2011 Audit of Ormond Beach Generating Station

August 2011

STAFF REPORT

Audit Report of Ormond Beach Generating Station

Photo 1: Typical Unit 2 Main Transformer (one for each phase).

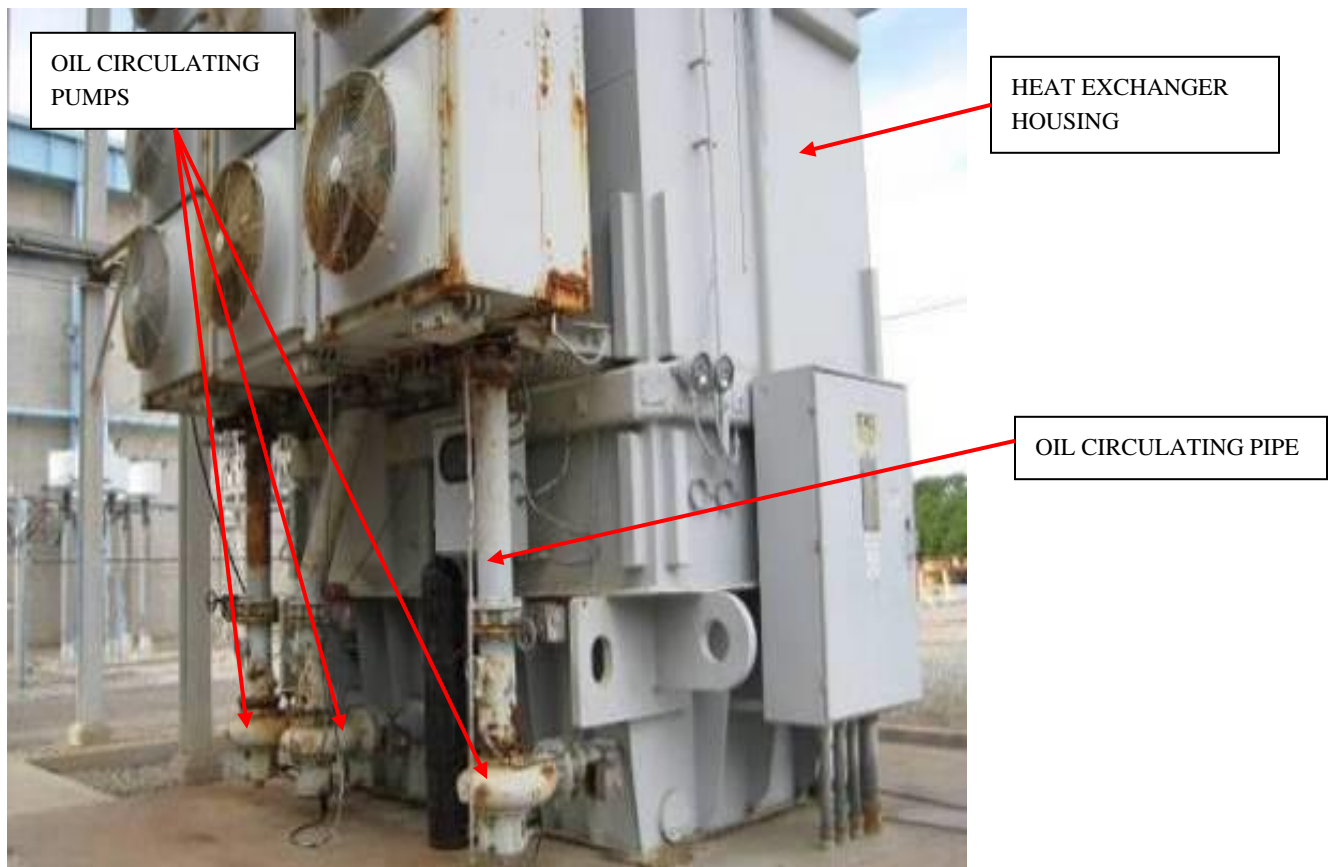
Second, severe corrosion to the Unit 2 main transformers jeopardizes safe operation (Photos 1-5). Unless repaired or replaced, the oil circulation pipes and heat exchanger housing on the Phase A, B and C transformers could leak or release hot oil into the immediate area, which increases the risk of fire and employee injury.

The plant's March 31, 2011 CAP proposes to replace the Unit 2 components with stainless steel piping/housing, similar to a recently-completed retrofit on Unit 1. The plant plans to complete the replacement by Spring 2012.

Photo 19: Cracked motor foundation.

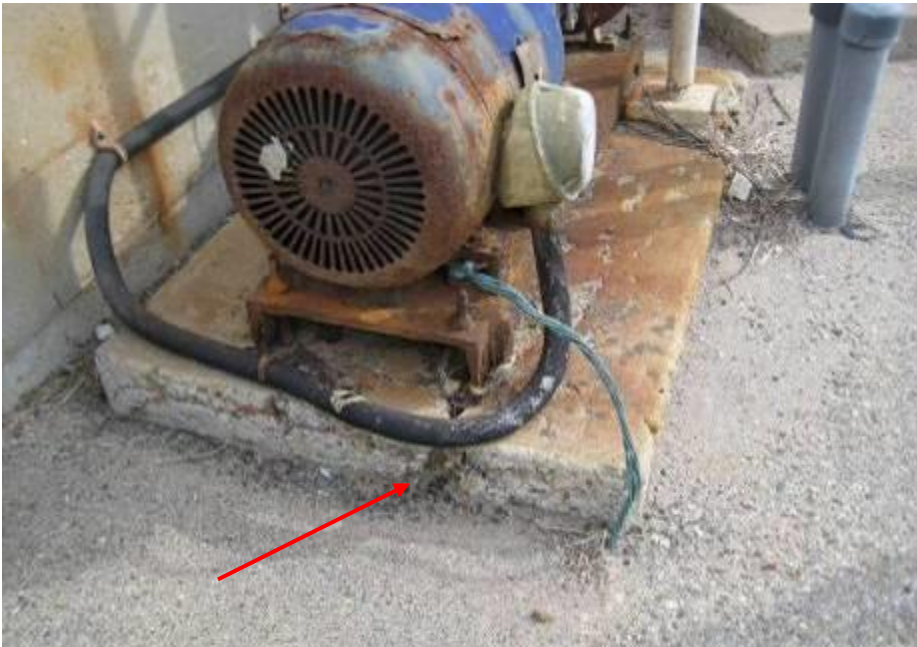
Similarly, the concrete foundation for the Mariculture Lab pump is cracked, and the metal pump base is corroded (Photos 19-20). The pump delivers sea water to a laboratory where the plant raises abalone.

Diagram 1: Block and Bleed Valve Arrangement for Isolating High Pressure Energy

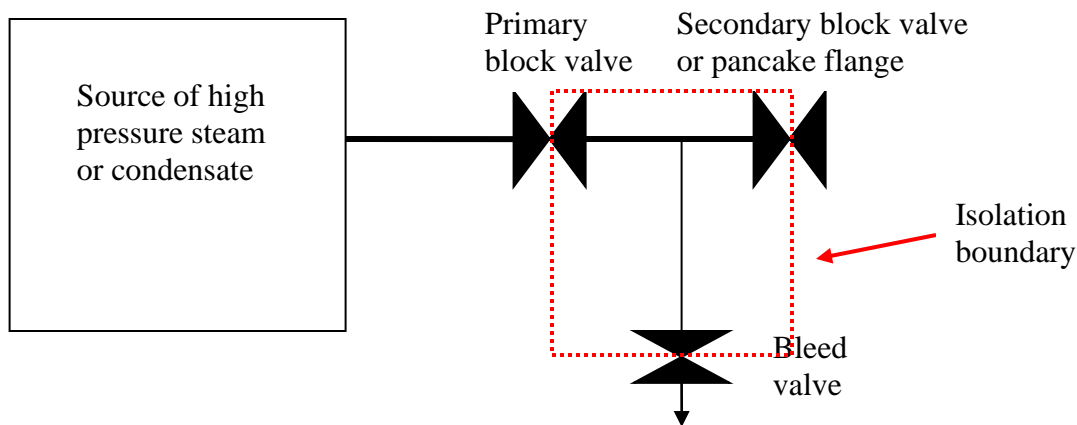
physical isolation method known as “block and bleed.”¹² The block and bleed method provides superior safety features (see Diagram 1 below) over single valve isolation, which increases protection for employees working on high energy systems. EGPB suspects the plant does not use “block and bleed” to physically isolate other high energy systems as well. To fully protect employees from potential high energy hazards, the plant’s physical isolation procedures could include the “block and bleed” method.

Photo 21: The plant's main transformers and concrete curb containment.

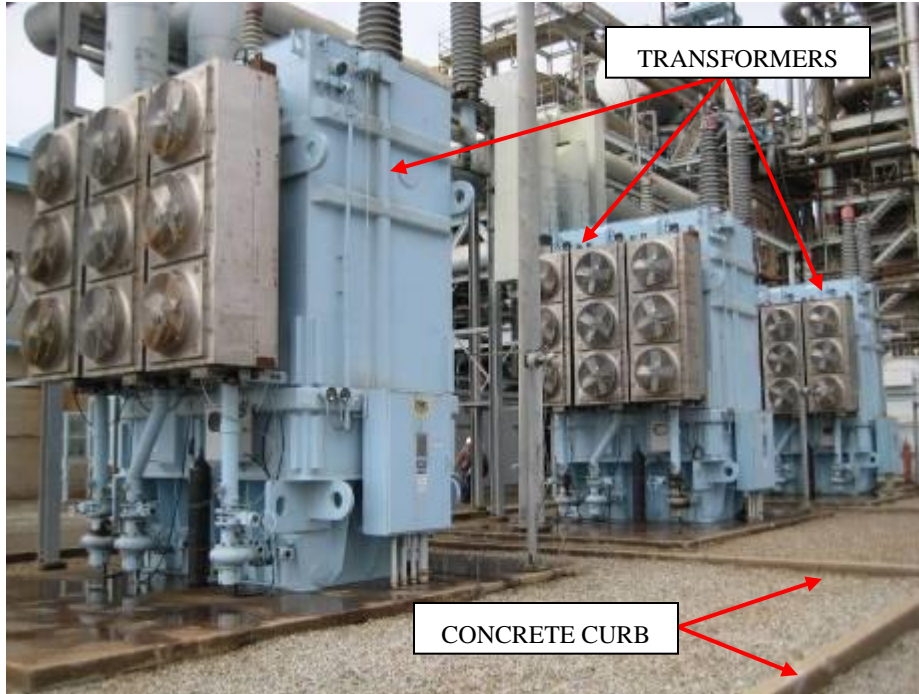
The plant’s main transformers lack fire protection, such as an automatic water spray system or a barrier wall.¹³

In October 2010, a contractor, “Global Risk Consultants,” performed a risk analysis on Ormond Beach’s fire protection system. The plant’s sole fire protection measure for the main transformers is concrete curb containment for oil leaks (Photo 21). The contractor recommended that the plant install automatic water spray systems on the main, auxiliary, and service transformers, in accordance with guidelines from the National Fire Protection Association (NFPA), Factory Mutual (FM) Global, and Electric Power Research Institute (EPRI).

As of February 2011, the plant had neither evaluated the contractor's recommendations nor installed additional fire protection on the transformers. While EGPB does not require plants to follow contractor recommendations, it does expect plants to evaluate such recommendations within a reasonable amount of time, and to explain and support any decision to implement or decline such recommendations.

Photo 22: An uninsulated BFP casing.

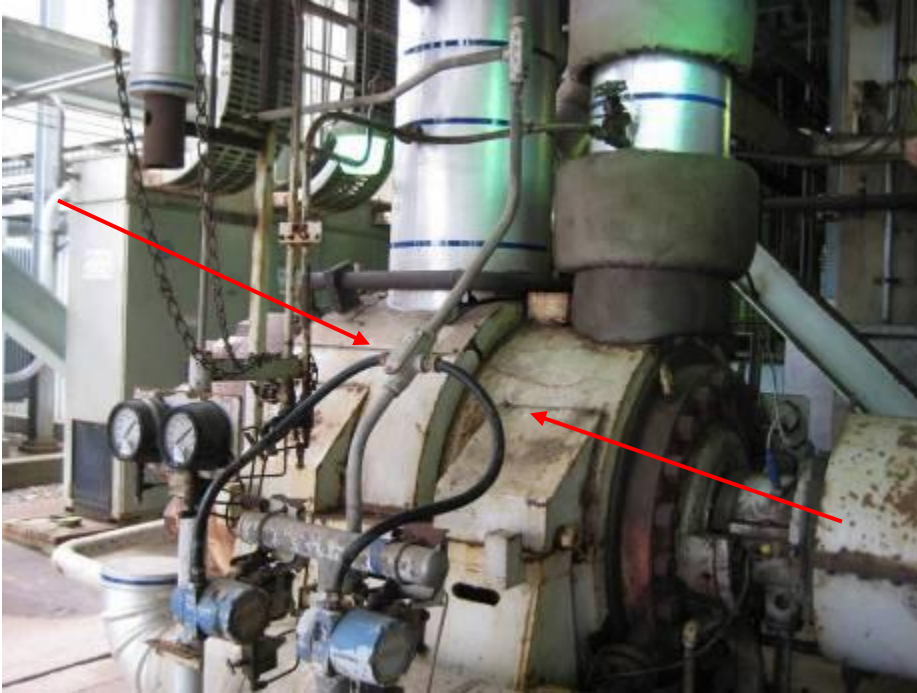
The plant failed to insulate the hot casing on four boiler feed pumps (BFP).¹⁴ Although the pumps are exposed to foot traffic, the plant has neither erected barricades nor posted warning signs to keep workers and visitors away from the hot casing (Photo 22). Plant staff stated that in the past, Ormond Beach insulated the pumps. EGPB strongly recommends that the plant install thermal insulation or other safety measures to minimize the burn hazards posed by the BFPs.

Photo 23: Damaged power cable exposes “hot” wiring.

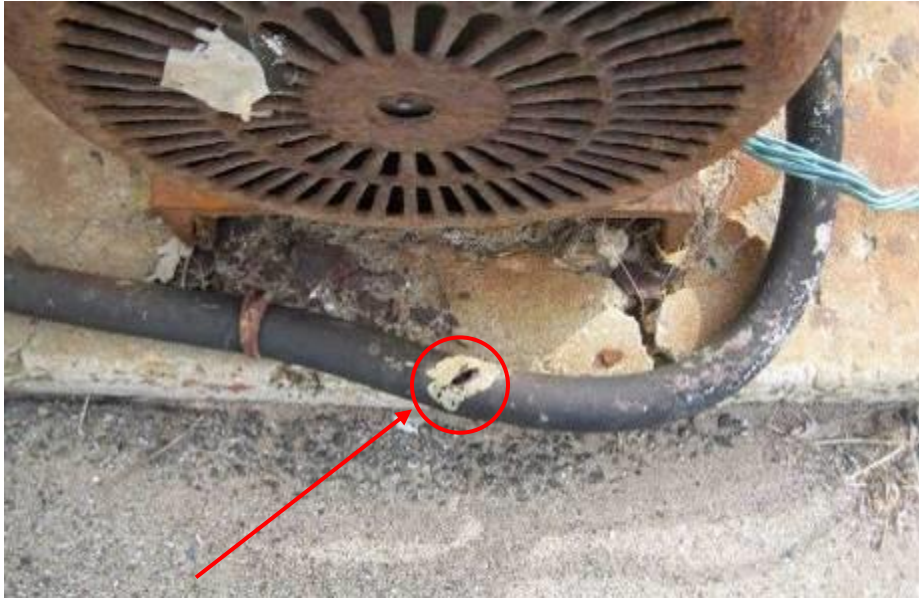
First, the plant failed to repair or replace a damaged power cable near the Mariculture Lab building. A hole in the cable insulation exposes energized electrical wire (Photo 23). Because the location is open to foot traffic, employees could come in contact with the energized wiring, resulting in an electric shock or electrocution. The plant failed to cordon off the area, post

warning signs or take other actions to protect employees until it repairs or replaces the damaged cable.

Photo 32: Deteriorated drywall flakes onto the lab bench.

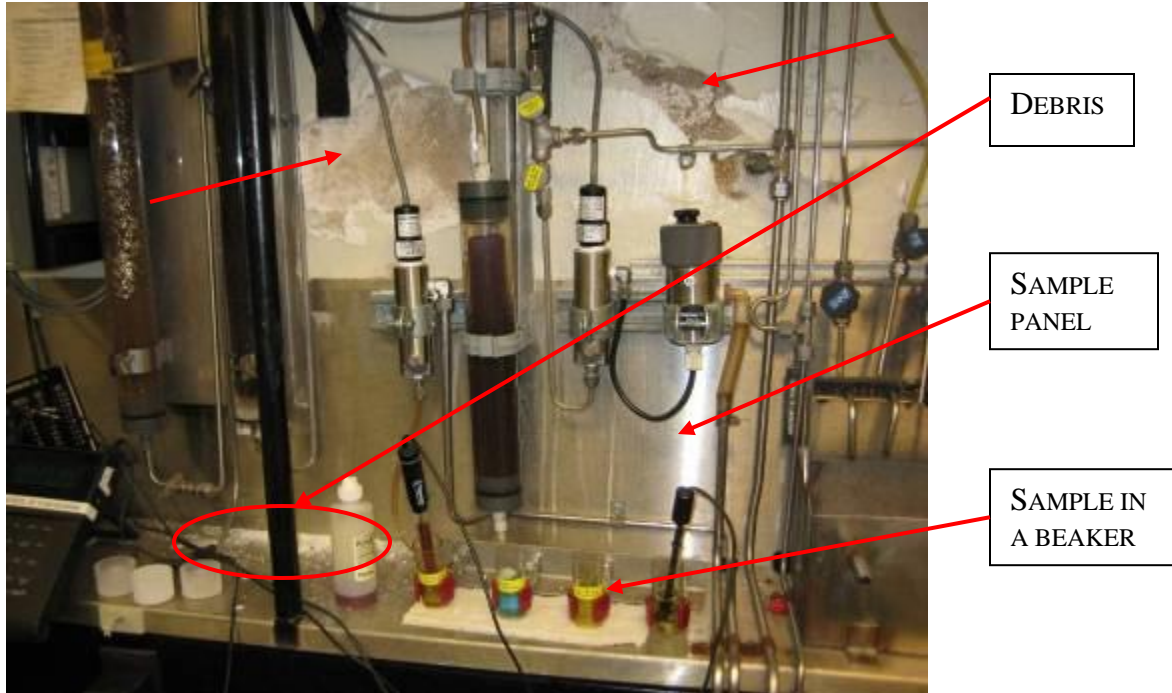
Poor housekeeping practices at the chemistry lab could accidentally contaminate test samples.²⁴ Flakes of deteriorated drywall fall onto the workstation (“grab sample” bench) where plant staff collects water samples and conduct tests. A panel system located behind the bench collects water samples from various sources in the plant. An accumulated pile of debris on the worktop surface indicates that the plant ignored the problem for quite some time. Because the deteriorated drywall is directly above the collected samples, debris may fall into open beakers, contaminate water samples, and adversely affect test results.

Photo 36: Hazmat training records provided to CPSD during the audit.

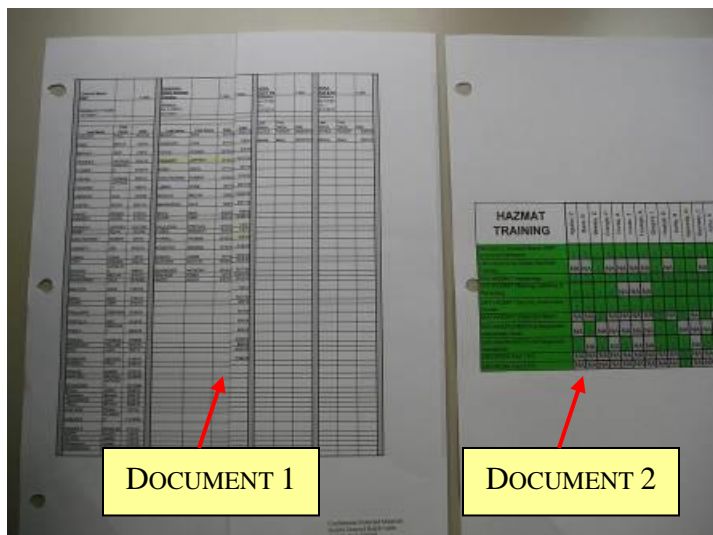
Finally, Ormond Beach is inconsistent in its record keeping practice for all training documents. For example, the plant’s two-page Hazardous Materials training records contain incorrect and conflicting information (Photo 36).

- “Hazardous Waste Manifest” Training: Documents 1 and 2 list a different first initial for an employee’s last name (unless two employees have the same last name).
- “HAZWOPER First Responder Operations” class: Document 1 and Document 2 each list class attendees. Document 2 fails to list two particular employees whose names appear on Document 1.
- Other classes: Document 1 states that an employee completed three classes, while Document 2 does not list that employee on the roster.
